TECHNICAL & SAFETY COMMITTEE

<p>Technical & Safety Information Notice No.</p>	<p>4/2013 SUPPLIER/VENDOR RECALL OF PS70104 HOUSINGS (METAL FLEX HOSING INC)</p> <p>ALLJA101---XX HARNESS CONTAINER ASSEMBLIES (JAVELIN ODYSSEY) WITH METAL FLEX HOUSING BATCH # 33234A AND 33227, 375ID PS70104 HOUSINGS. W.N. 46</p>																																																																													
<p>Date of Issue</p>	<p>23 May 2013</p>																																																																													
<p>Subject Matter and Applicability</p>	<p>SUN PATH SERVICE BULLETIN SPSB009</p> <p>DATE: May 23, 2013</p> <p>SERVICE BULLETIN # SPSB009</p> <p>SUBJECT: SUPPLIER/VENDOR RECALL OF PS70104 HOUSINGS (METAL FLEX HOSING INC)</p> <p>STATUS: MANDATORY INSPECTION AND REPLACEMENT OF RECALLED HOUSINGS.</p> <p>IDENTIFICATION: ALL JA101---XX HARNESS CONTAINER ASSEMBLIES (JAVELIN ODYSSEY) WITH METAL FLEX HOUSING BATCH # 33234 A AND 33227, .375ID PS70104 HOUSINGS. SEE SERIAL NUMBER LIST BELOW.</p>

SERVICE BULLETIN: MANDATORY INSPECTION (COMPLIANCE WITH METAL FLEX HOSING MATERIAL RECALL)

WEARER'S LEFT SIDE

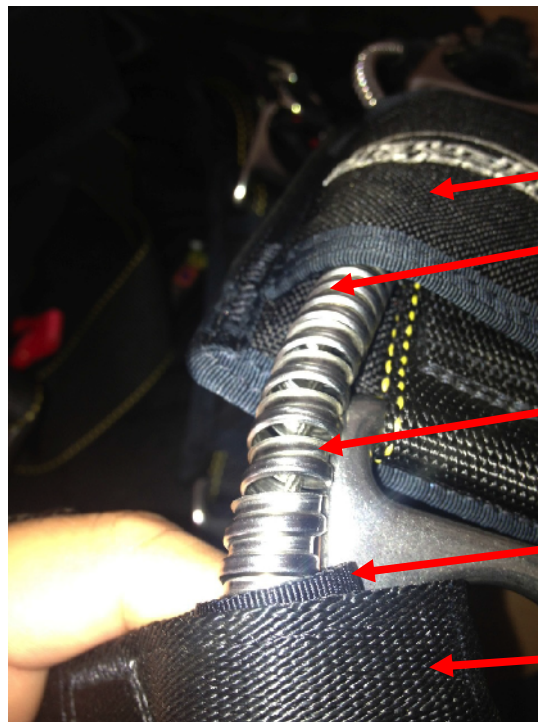
What to inspect: All JA101---XX harness container systems listed in table above. Inspect Reserve Ripcord housing.

PROCEDURE: If the serial number is listed in the above table, inspect the available exposed reserve ripcord housing. Locate the lower end of the housing, which is clamped to the Main Lift Web, just above the reserve ripcord pocket. Inspect the exposed length of housing from the

<p>clamp upwards; ensure that the coil has not separated/unraveled. Be sure to inspect the section that is routed through the chest strap.</p> <p>Inspection Results:</p> <p>A. HOUSING FOUND TO BE INTACT (GOOD): The rig may continue to be jumped with periodic monitoring until the next repack cycle or earlier elective replacement. However this housing must be replaced at the next repack cycle. See http://www.sunpath.com/support/HousingReplacement.pdf for instructions for your rigger to complete the replacement of the housing.</p> <p>B. HOUSING FOUND TO BE SEPERATED/UNRAVELLED (BAD): The housing must be replaced before the next jump by a certificated senior or master parachute rigger (or foreign equal) or the manufacturer. See http://www.sunpath.com/support/HousingReplacement.pdf for instructions for your rigger to complete the replacement of the housing or instructions to send your system back to the manufacturer.</p> <p>Resolution:</p> <p>A: Housing is intact and will be monitored and replaced at the inspection/repack cycle.</p> <ol style="list-style-type: none"> NOTE ON PACKING DATA CARD, SPSB009 COMPLETED AT TIME OF REPLACEMENT, FILL OUT WEB FORM AND SUBMIT at http://www.sunpath.com/Metal---FlexRecall.html and add “--Replaced “ after SPSB009 COMPLETED from step 1 above. NO FURTHER ACTION REQUIRED <p>B. HOUSINGS ARE SEPERATED/UNRAVELLED:</p> <ol style="list-style-type: none"> GO TO http://www.sunpath.com/support/HousingReplacement.pdf FOR FURTHER INSTRUCTIONS ON REPLACEMENT OF THE SUBJECT HOUSINGS. AT TIME OF REPLACEMENT, FILL OUT WEB FORM AND SUBMIT at http://www.sunpath.com/Metal---FlexRecall.html; NOTE ON PACKING DATA CARD AND RIGGER LOG BOOK, SPSB009 COMPLETED--REPLACED. NO FURTHER ACTION REQUIRED. <p>COMPLIANCE DATE: INSPECTION BEFORE NEXT JUMP (BY ANYONE) AND MANDATORY HOUSING REPLACEMENT AT NEXT REPACK CYCLE BY FAA SENIOR OR MASTER PARACHUTE RIGGER OR FOREIGN EQUAL.</p>

Compliance	INSPECTION BEFORE NEXT JUMP (BY ANYONE) AND MANDATORY HOUSING REPLACEMENT AT NEXT REPACK CYCLE BY FAA SENIOR OR MASTER PARACHUTE RIGGER OR FOREIGN EQUAL.MANDATORY INSPECTION AND REPLACEMENT OF RECALLED HOUSINGS.
Concerned Publication	Sun Path Service Bulletin # SPSB009 dated 20 May 2013.
Authority	AUTHORITY:
